ADDENDUM NO. 1
Invitation for Bids
Kirk Hangar Foundation Installation

KIRK HANGAR
DEVELOPMENT

SITE PLAN EXHIBIT

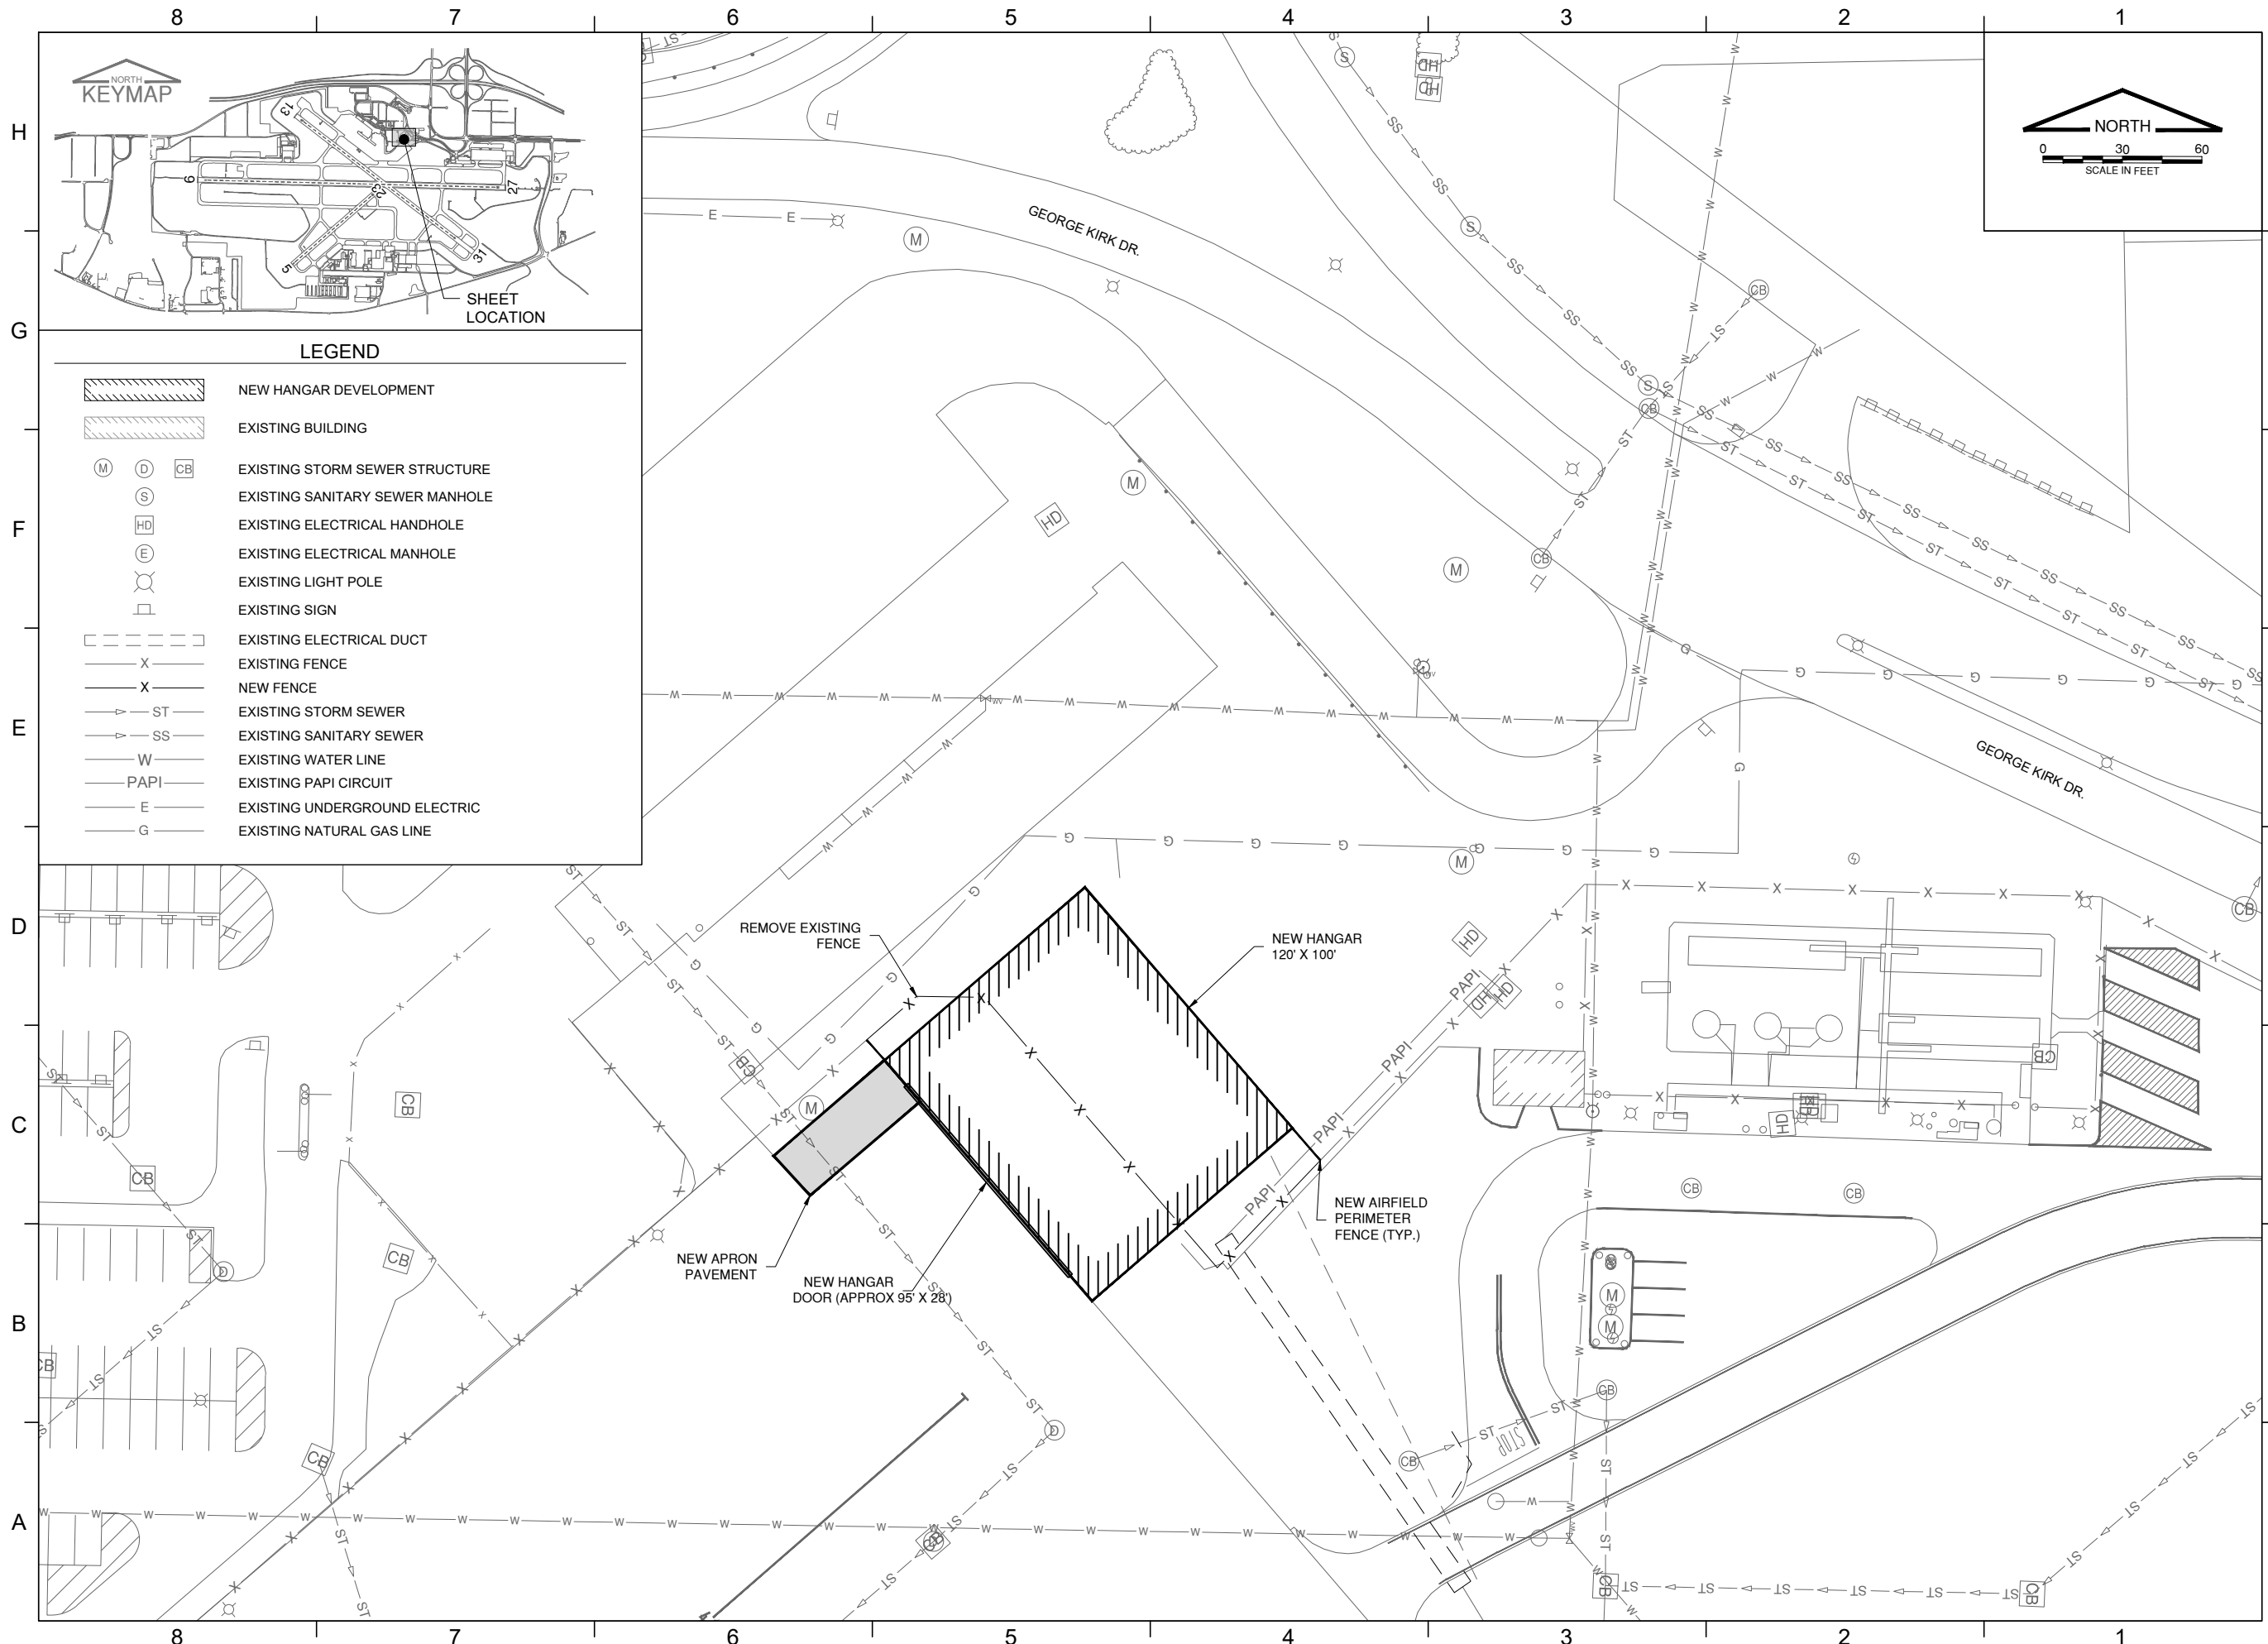
The IFB is hereby amended to include a **Development Site Exhibit**, identified as **Schedule D**, depicting the general location, limits, and boundaries of the proposed hangar development area.

Schedule D is provided for informational and coordination purposes and is intended to assist bidders in understanding site access, orientation, and general development context. Bidders are responsible for verifying all site conditions and dimensions as required by the IFB.
